**NEW YORK STATE THRUWAY AUTHORITY
DEPARTMENT OF ENGINEERING**

**AMENDMENT NO. 5
TO**

**CONTRACT TANY 26-17B
D215020
REPLACEMENT OF THE PINE HILL ROAD
BRIDGE OVER I-87 AT MP 47.58,
REHABILITATION OF I-87 BRIDGE OVER
SMITH CLOVE ROAD AT MP 47.04,
AND RESURFACING AND SAFETY IMPROVEMENTS
ON I-87 BETWEEN MP 46 AND MP 48
IN THE NEW YORK DIVISION
OF THE NEW YORK STATE THRUWAY
IN ORANGE COUNTY**

**IN THE LETTING OF
JUNE 24, 2026**

CONTRACT NUMBER:
TANY 26-17B
DATE:
05/21/2025
DRAWING NUMBER:
WZTC-1-02

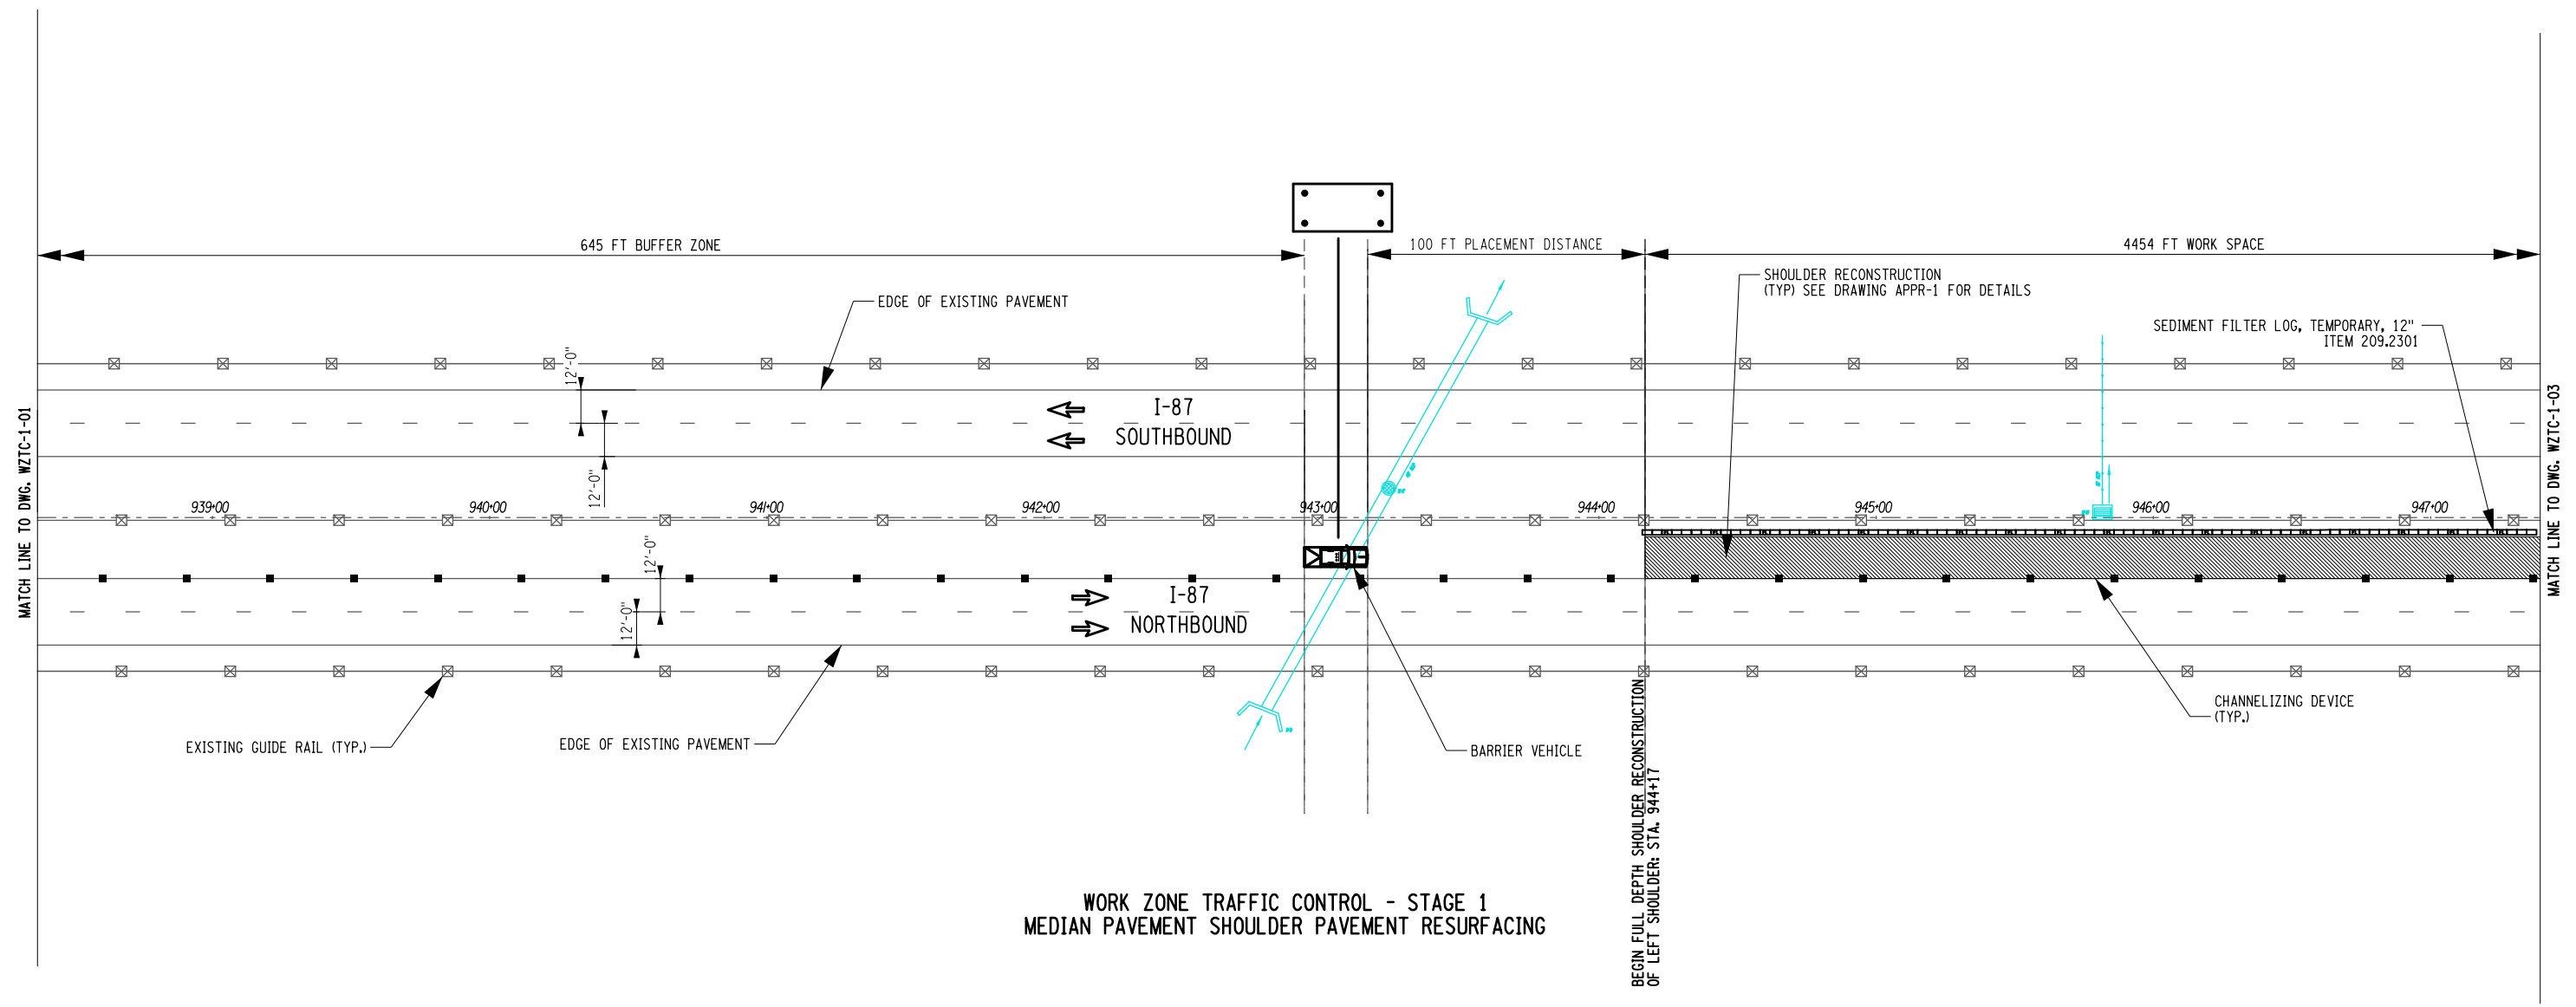
9. **DELETE** Drawing Number WZTC-1-02, Sheet 118 of 180, and **SUBSTITUTE** with the attached Drawing Number WZTC-1-02, Sheet 118A5 of 180. A printing error affecting line styles for Temporary Concrete Barrier, channelizers, and sediment filter logs have been corrected. In the Legend and as called out near Station 947+00 (upper right), the prospective bidder is to revise any previous reference in the drawing for Item 209.2301, Sediment Filter Log Temporary, 12" to read as Item 209.1311, Sediment Filter Log - Temporary, 12", Type A, instead.

TITLE OF PROJECT: I-87 BRIDGE REHABILITATION OVER SMITH CLOVE ROAD (MP 47.04)	CONTRACT NUMBER: TANY 26-17B
LOCATION OF PROJECT: VILLAGE OF WOODBURY ORANGE COUNTY BIN 5514279	DATE: 05/21/2025
TITLE OF DRAWING: I-87 WORK ZONE TRAFFIC CONTROL PLAN STAGE 1 (3 OF 7)	DRAWING NUMBER: WZTC-1-03

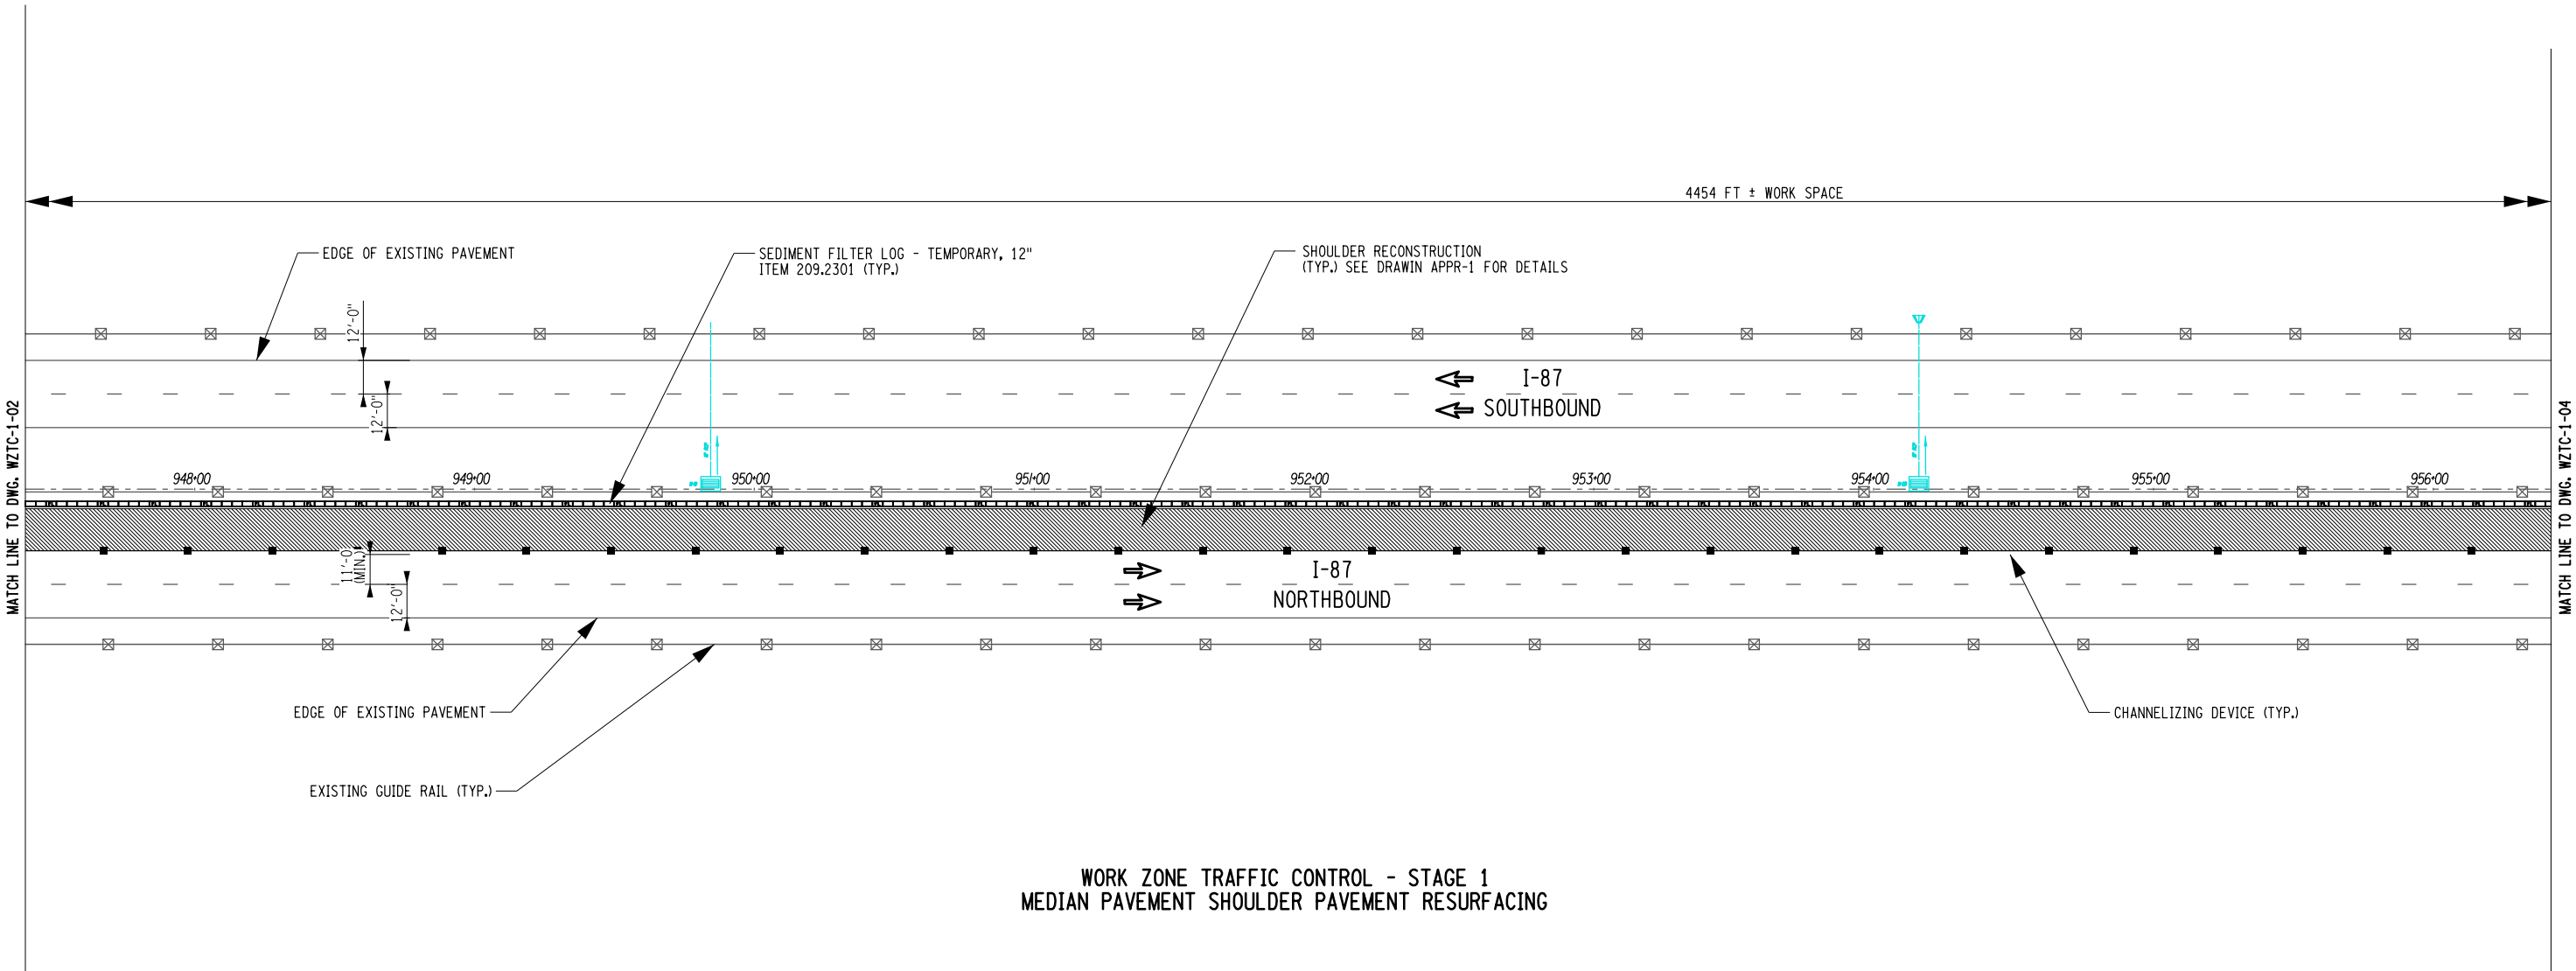
10. **DELETE** Drawing Number WZTC-1-03, Sheet 119 of 180, and **SUBSTITUTE** with the attached Drawing Number WZTC-1-03, Sheet 119A5 of 180. A printing error affecting line styles for Temporary Concrete Barrier, channelizers, and sediment filter logs have been corrected. In the Legend and as called out near Station 950+00 (upper left of middle), the prospective bidder is to revise any previous reference in the drawing for Item 209.2301, Sediment Filter Log Temporary, 12" to read as Item 209.1311, Sediment Filter Log - Temporary, 12", Type A, instead.

TITLE OF PROJECT I-87 BRIDGE REHABILITATION OVER SMITH CLOVE ROAD (MP 47.04)	CONTRACT NUMBER: TANY 26-17B
	LOCATION OF PROJECT VILLAGE OF WOODBURY ORANGE COUNTY BIN 5514279	DATE: 05/21/2025
	TITLE OF DRAWING I-87 WORK ZONE TRAFFIC CONTROL PLAN STAGE 1 (4 OF 7)	DRAWING NUMBER: WZTC-1-04

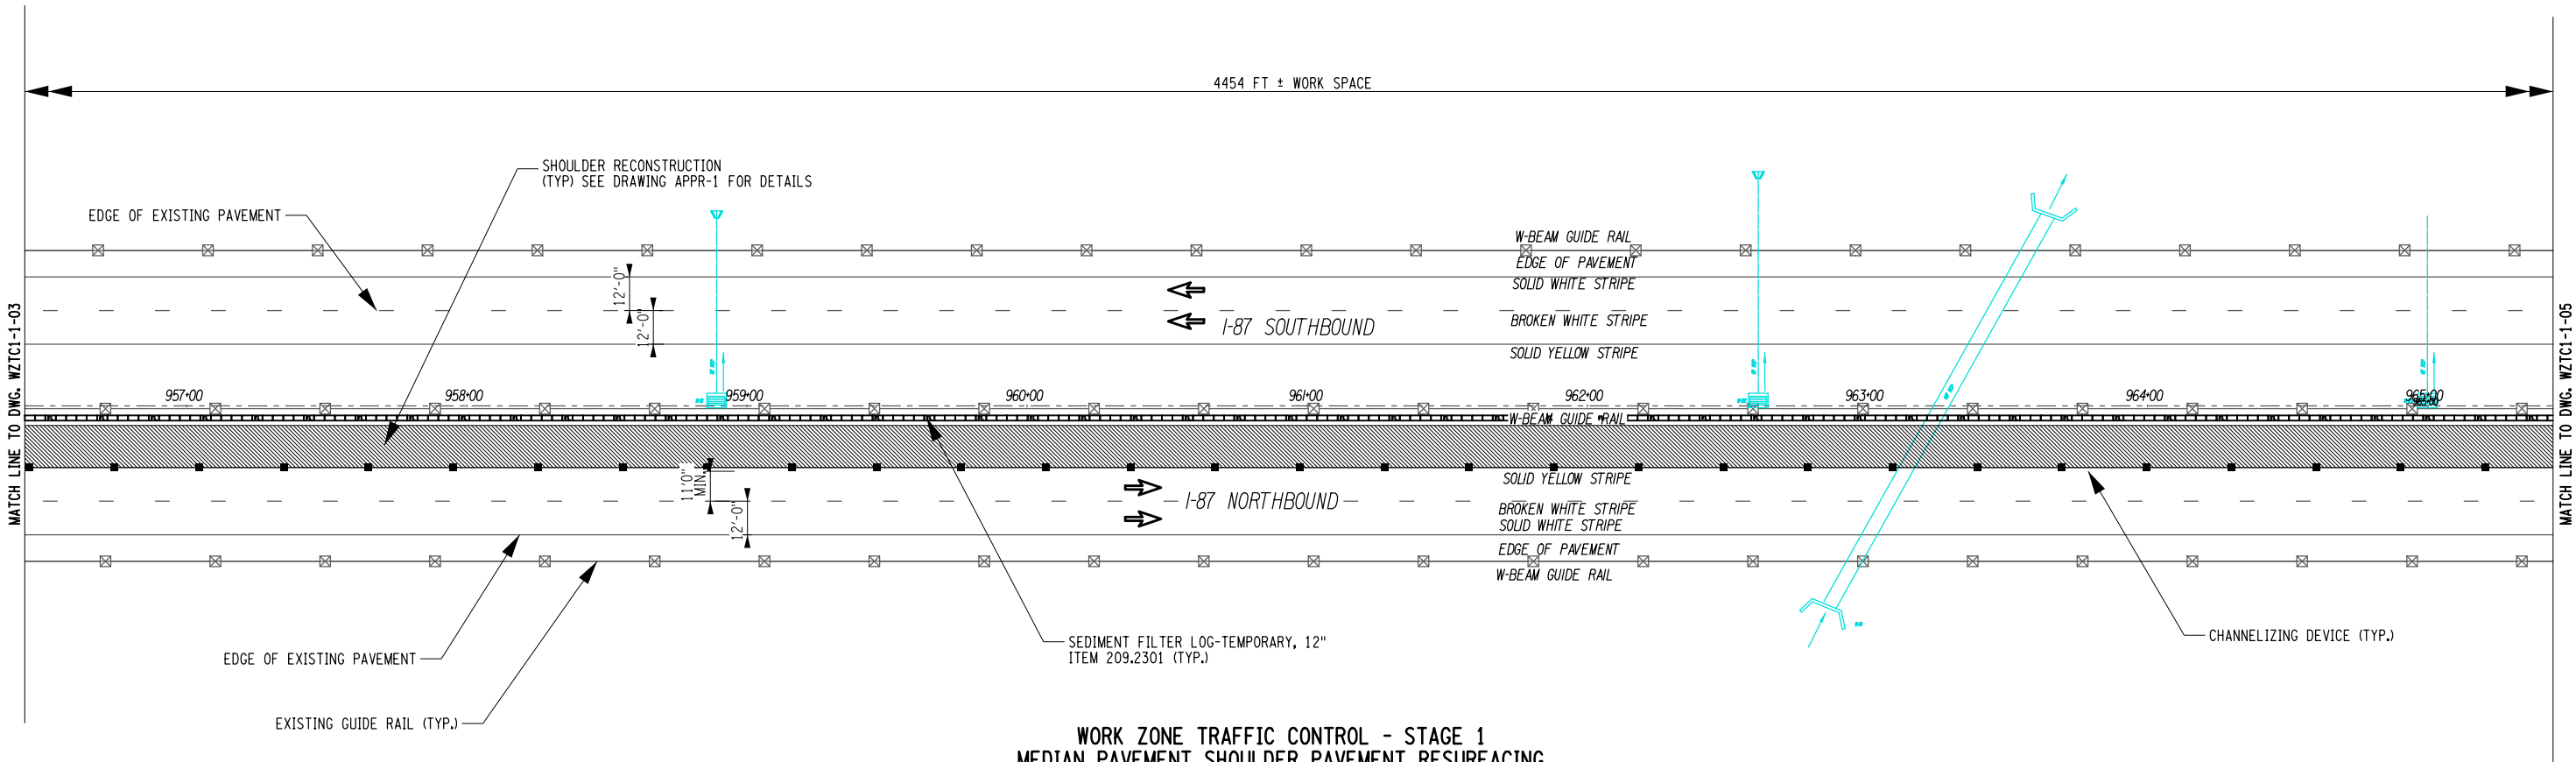
11. **DELETE** Drawing Number WZTC-1-04, Sheet 120 of 180, and **SUBSTITUTE** with the attached Drawing Number WZTC-1-04, Sheet 120A5 of 180. A printing error affecting line styles for Temporary Concrete Barrier, channelizers, and sediment filter logs have been corrected. In the Legend and as called out near Station 960+00 (bottom middle), the prospective bidder is to revise any previous reference in the drawing for Item 209.2301, Sediment Filter Log Temporary, 12" to read as Item 209.1311, Sediment Filter Log - Temporary, 12", Type A, instead.

DRAWING NUMBER:
WZTC-1-05

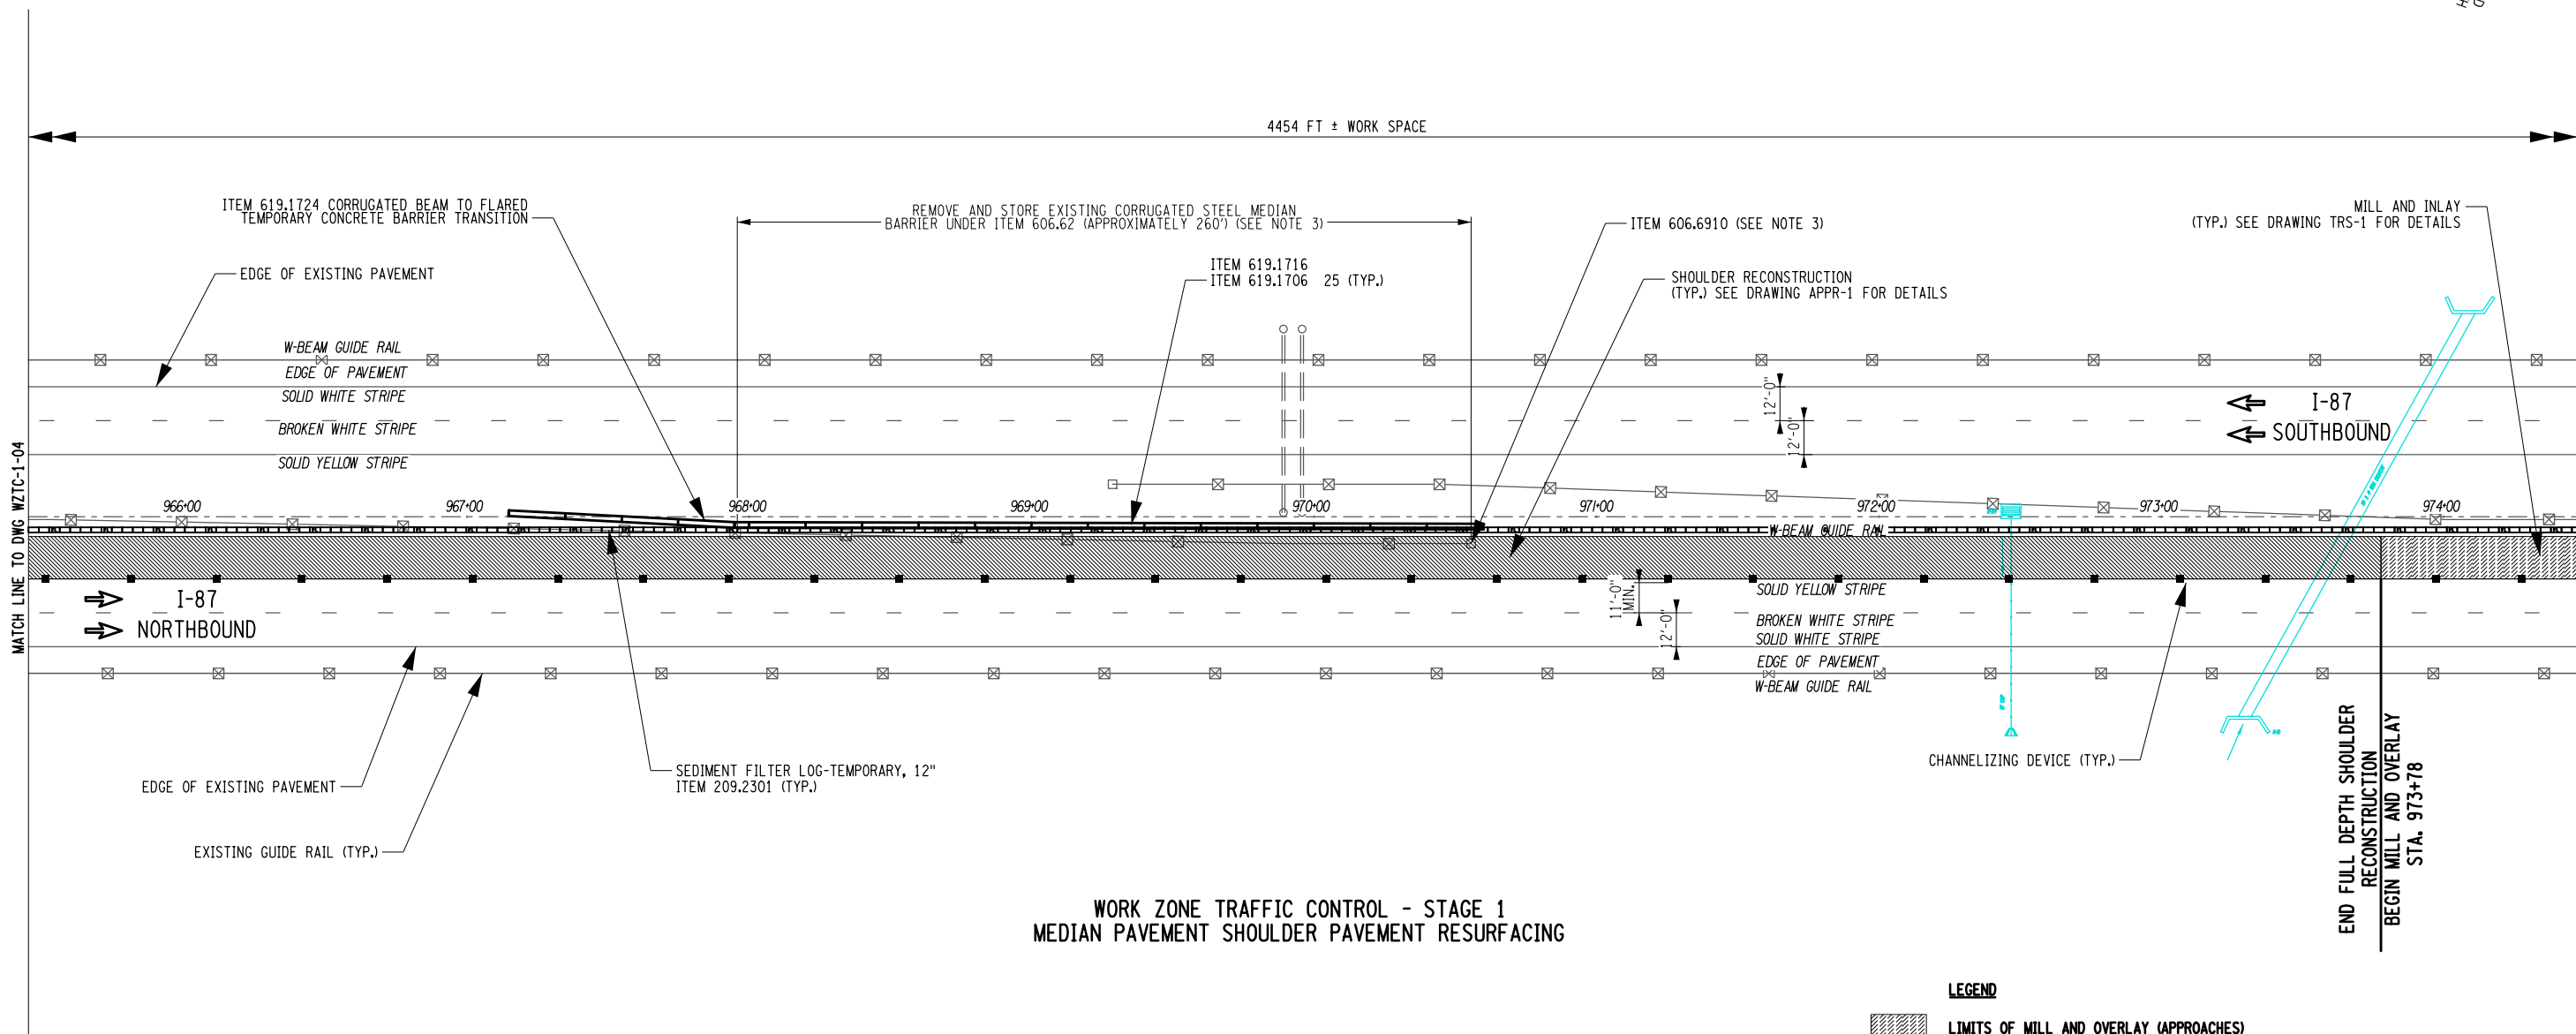
12. **DELETE** Drawing Number WZTC-1-05, Sheet 121 of 180, and **SUBSTITUTE** with the attached Drawing Number WZTC-1-05, Sheet 121A5 of 180. A printing error affecting line styles for Temporary Concrete Barrier, channelizers, and sediment filter logs have been corrected. In the Legend and as called out near Station 968+00 (middle left), the prospective bidder is to revise any previous reference in the drawing for Item 209.2301, Sediment Filter Log Temporary, 12" to read as Item 209.1311, Sediment Filter Log - Temporary, 12", Type A, instead.
